Appendix A: Addendum to Design and Access Statement to explain revised scheme - pg 1

Planning Ref: HGY/2022/2212

Revised Scheme
43 Belmont Avenue N17 6AX
Proposed Block plan (showing lower ground floor)
Scale: 1:200@A3 May 2022 **PP_09 revA**

PP_14 revA

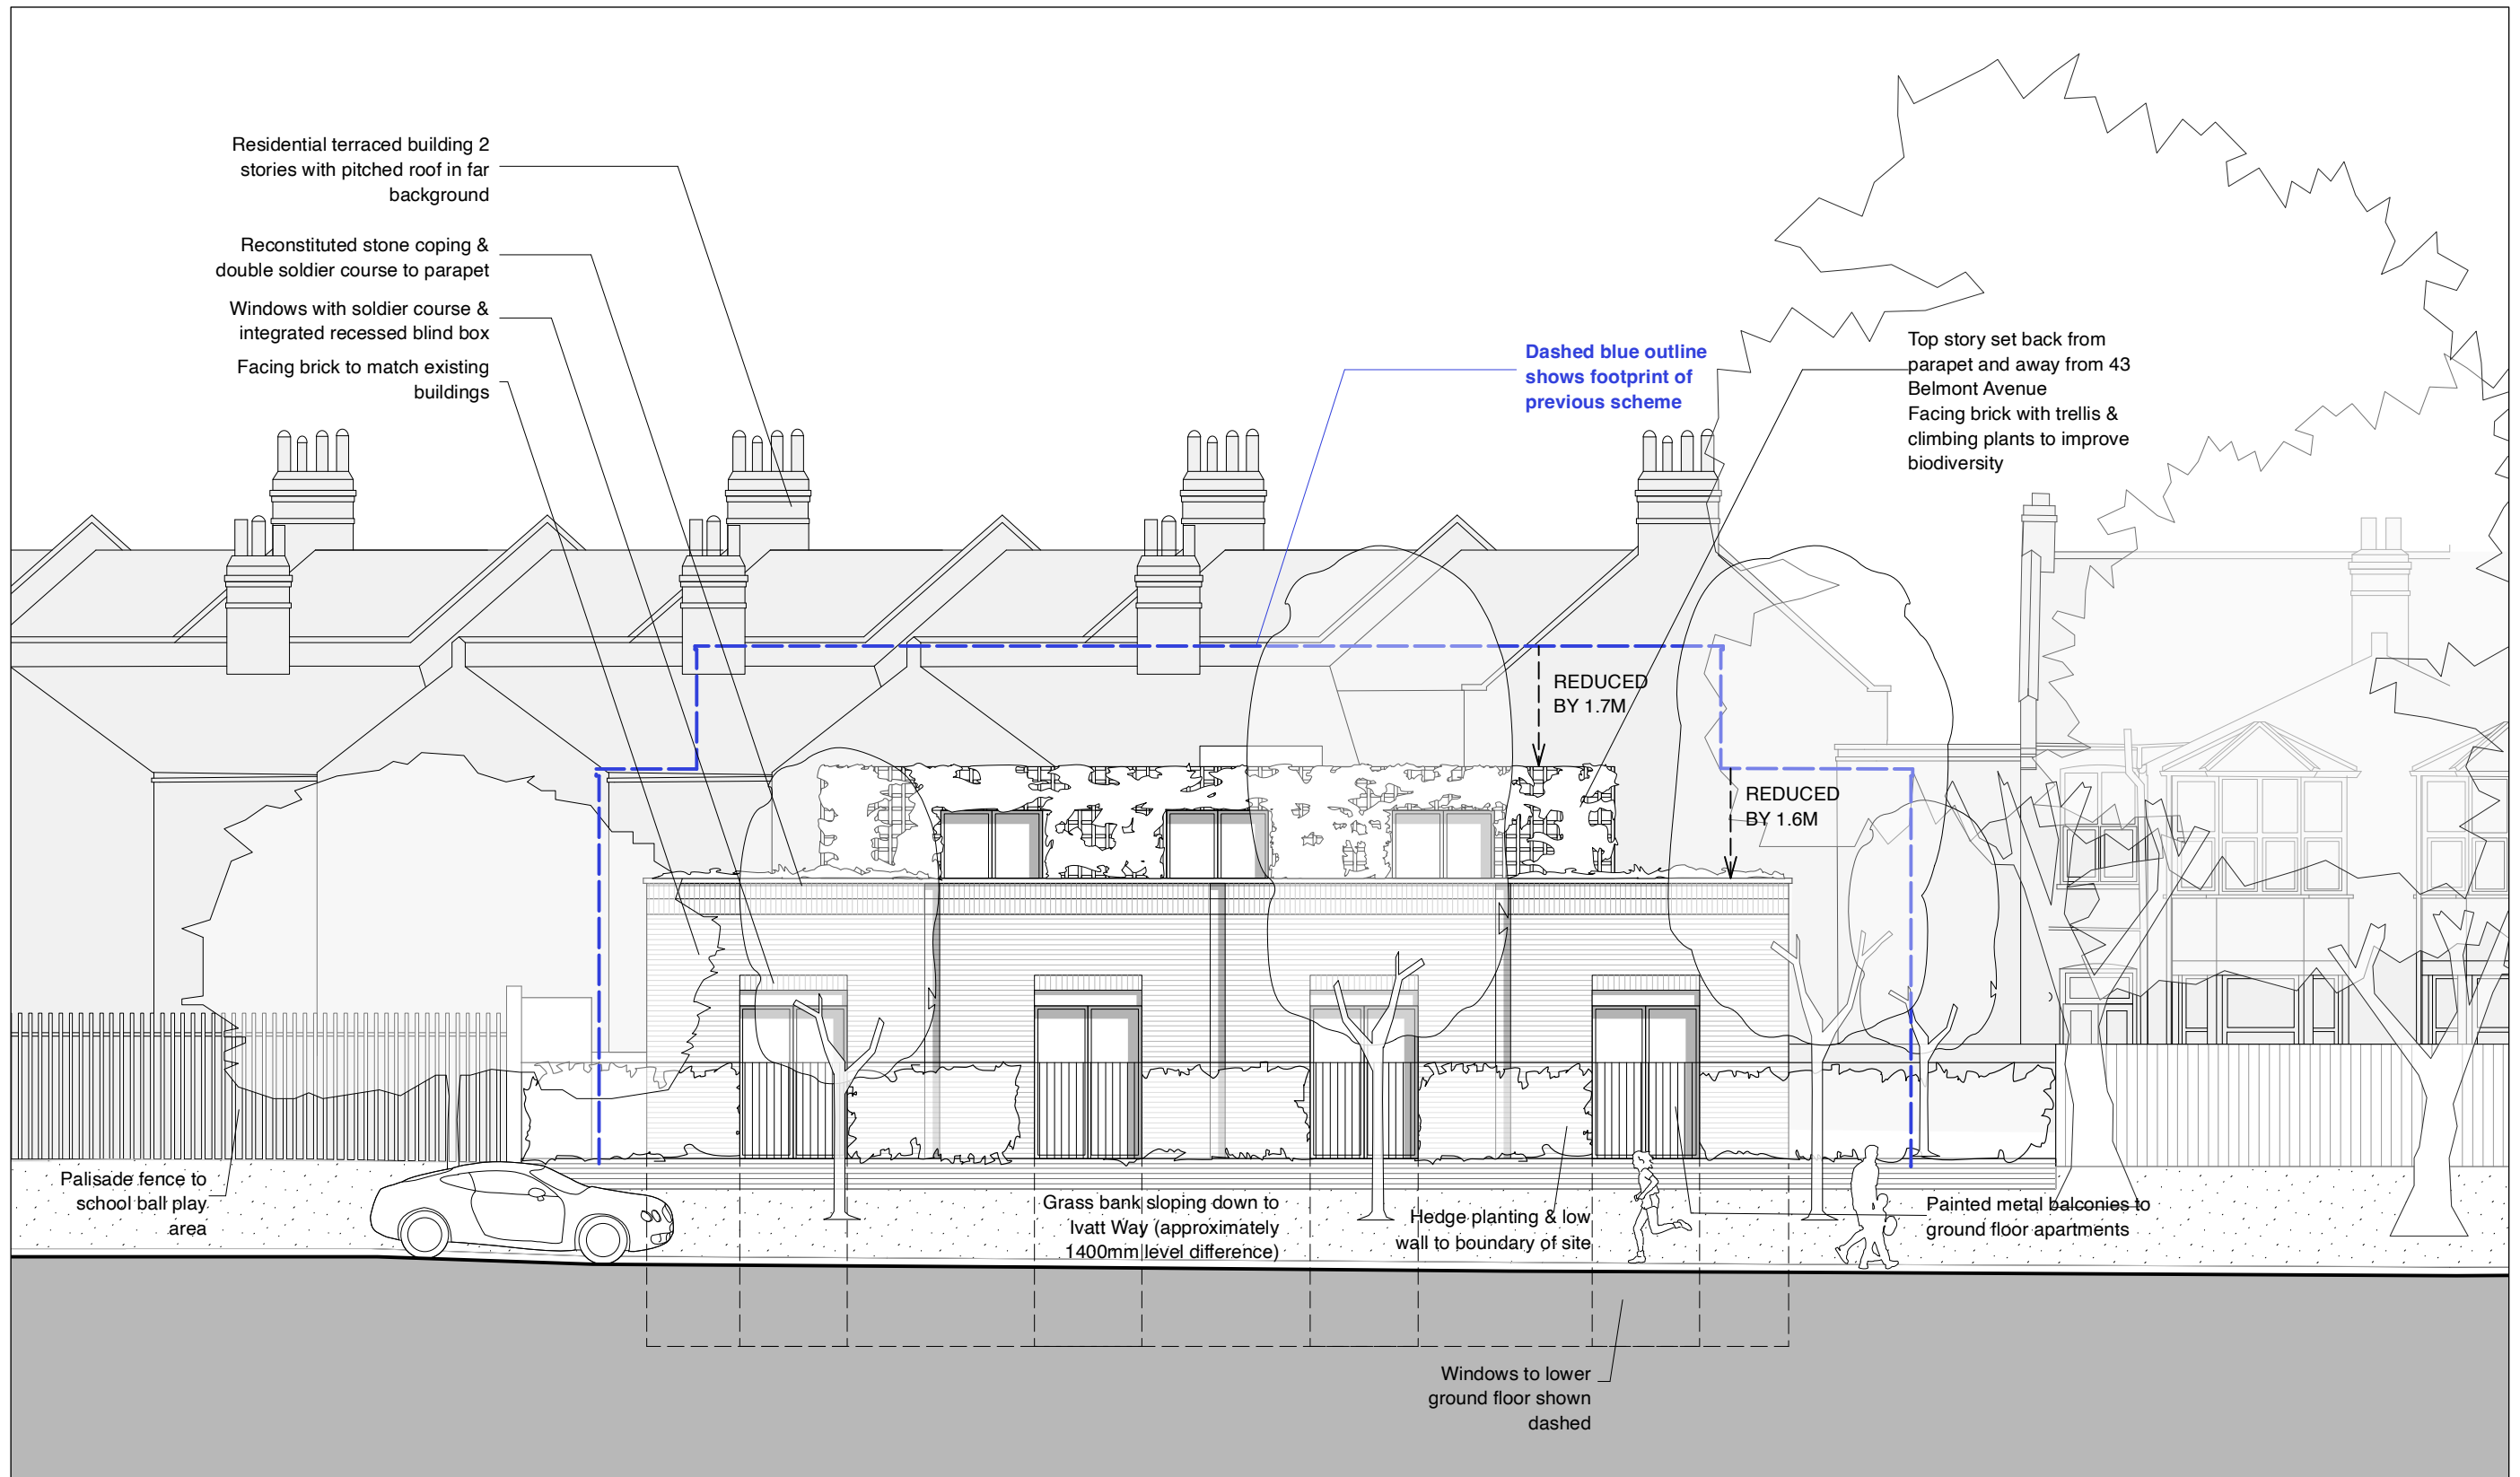
- Scheme re-designed to significantly reduce overall footprint, height and massing of the proposed development.
- The gross internal area is reduced by 80 m2 or 20% overall from the original design; the equivalent to a three bedroom apartment.
- Proposed accommodation reduced from five, two bedroom flats down to a mix of three one bedroom flats and two, two bedroom flats.
- The revised design is set back from all site boundaries as shown to avoid impact on neighbouring properties and their gardens.
- Windows have been relocated to avoid any potential overlooking to neighbouring properties and their gardens.
- The size and quality of outdoor amenity space has been increased to all proposed units.
- Landscape proposal has been revised to increase planting and relocate recycling and refuse stores as well as secure bicycle storage.

PP_15 revA

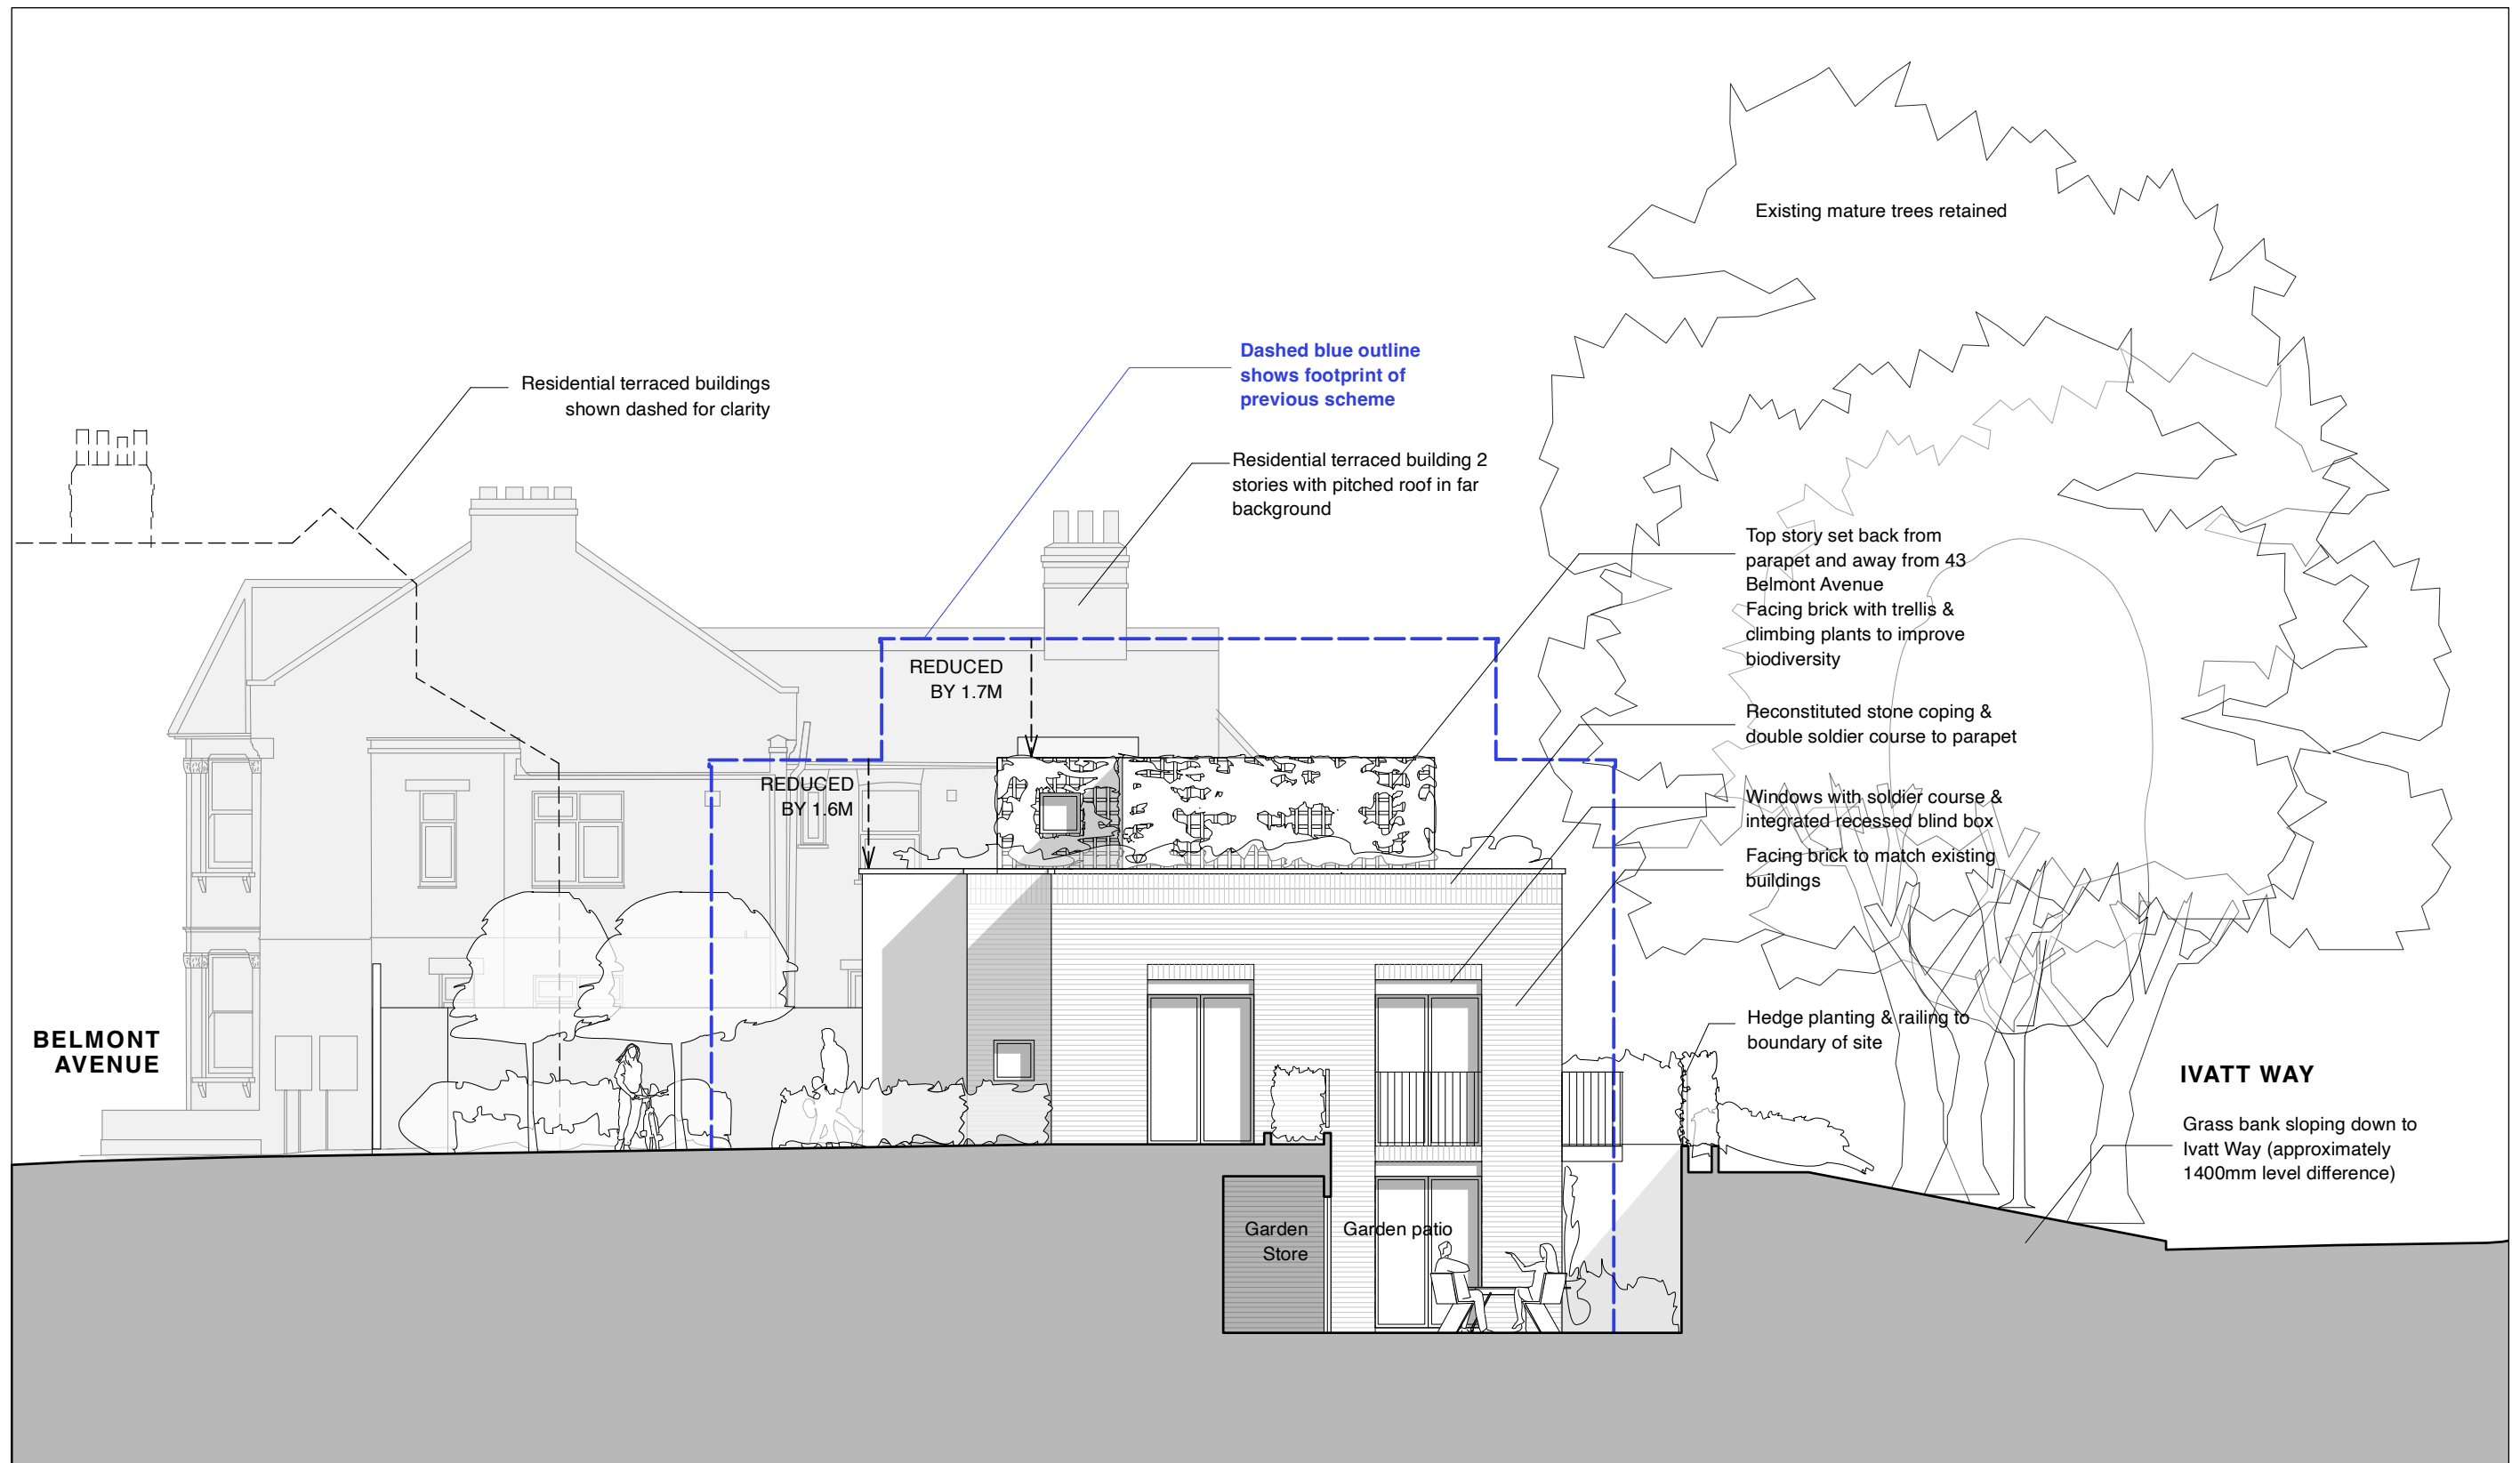
- Scheme re-designed to significantly reduce overall footprint, height and massing of the proposed development.
- The gross internal area is reduced by 80 m2 or 20% overall from the original design; the equivalent to a three bedroom apartment.
- Proposed accommodation reduced from five, two bedroom flats down to a mix of three one bedroom flats and two, two bedroom flats.
- The revised design is set back from all site boundaries as shown to avoid impact on neighbouring properties and their gardens.
- Windows have been relocated to avoid any potential overlooking to neighbouring properties and their gardens.
- The size and quality of outdoor amenity space has been increased to all proposed units.
- Landscape proposal has been revised to increase planting and relocate recycling and refuse stores as well as secure bicycle storage.
